ZONING BOARD OF APPEALS

Review of Plans: 897 Route 9W Site Plan, 897 Route 9W, Upper Grandview, NY  
Section 71.17 Block 1 Lot 13 R-22 zone

Proposed two car garage

Subject: **897 Route 9W Site Plan** **PB #23-36**  
Critical Environmental Area  
Prepreliminary/ Preliminary/ Final Site Plan and SEQRA Review  
897 Route 9W, Upper Grandview  
71.17/1/13; R-22 zoning district

1 PLOT PLAN SCALE: 1/16" = 1'-0"

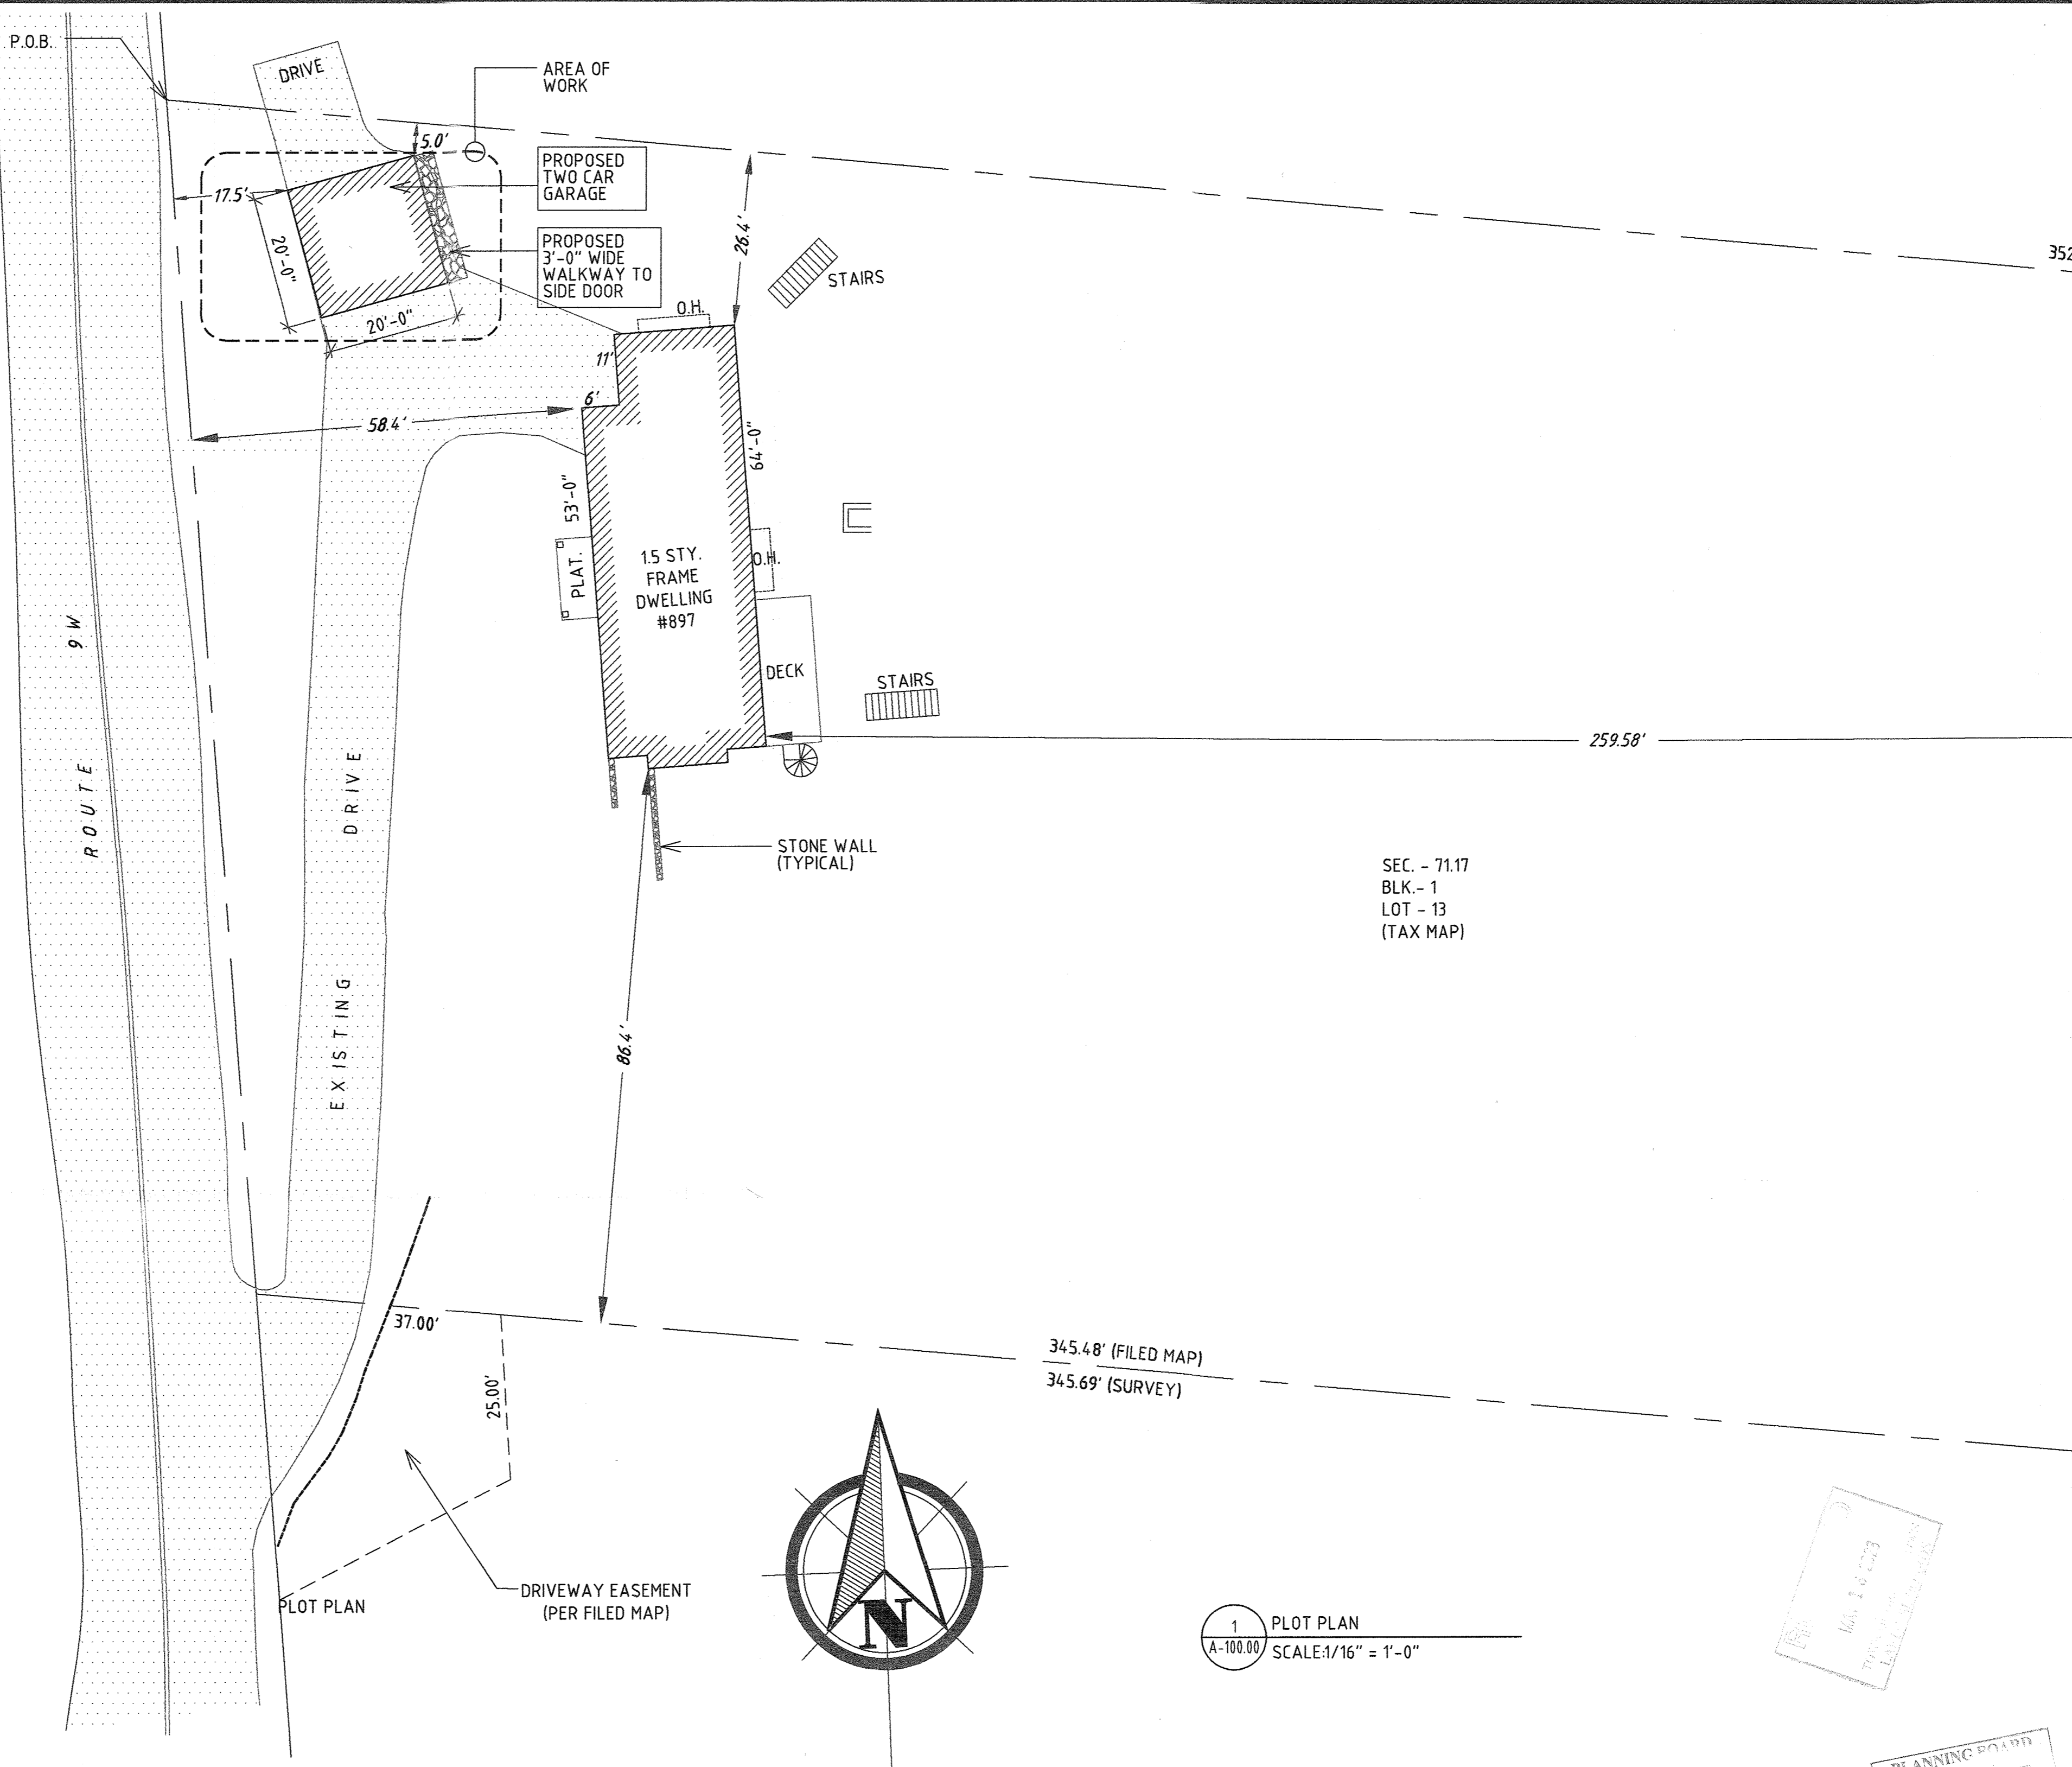
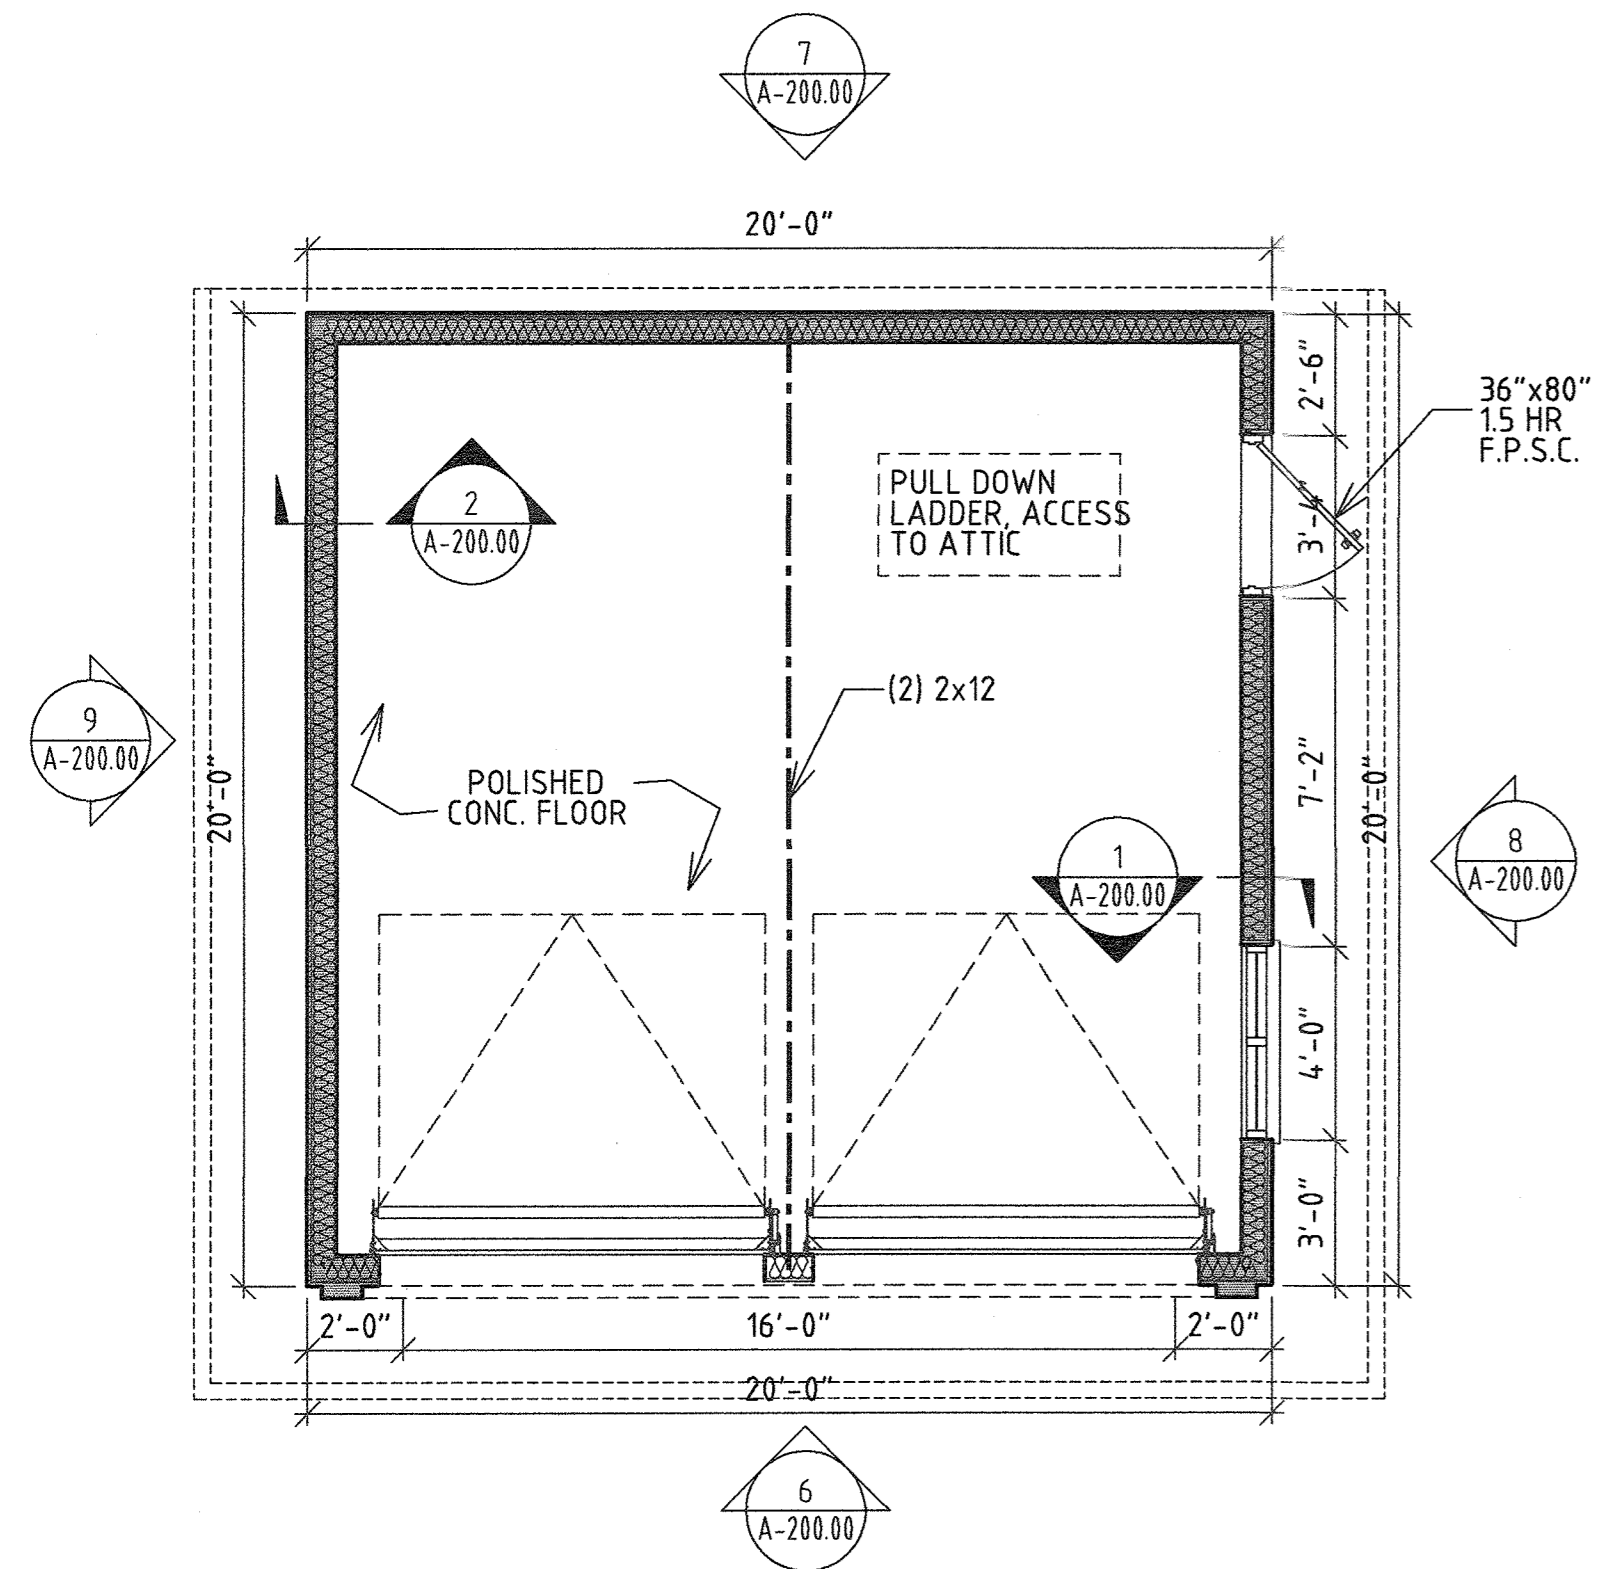
Plot plan as prepared by Rudy Dupuy Architects, dated 4-4-23.

- 1) The applicant must submit a to scale property survey prepared by a licensed surveyor that show all of the existing conditions, setbacks and grading in the area of the proposed work.
- 2) The applicant must submit drawings that contain all information required per town code section 21A-13.
- 3) The zoning bulk table on the plot plan must show the proposed zoning setbacks to the new two car garage.
- 4) Per Chapter 43 the following variances are required;

Table 3.12, R-22 district, column 8, front yard setback required is 40 feet with 17.5 proposed.

Article V, section 5.22; "All required yards, shall be unobstructed except as provided for in this section."

Section 5.224; "no enclosed accessory off-street parking space, including a garage, is permitted in a required front yard. However, where, by reason of exceptional topography, it is impractical to construct an accessory garage behind the required front yard, the Board of Appeals may permit the construction of not more than two enclosed parking spaces within a required front yard, accessory to a single-family residence."
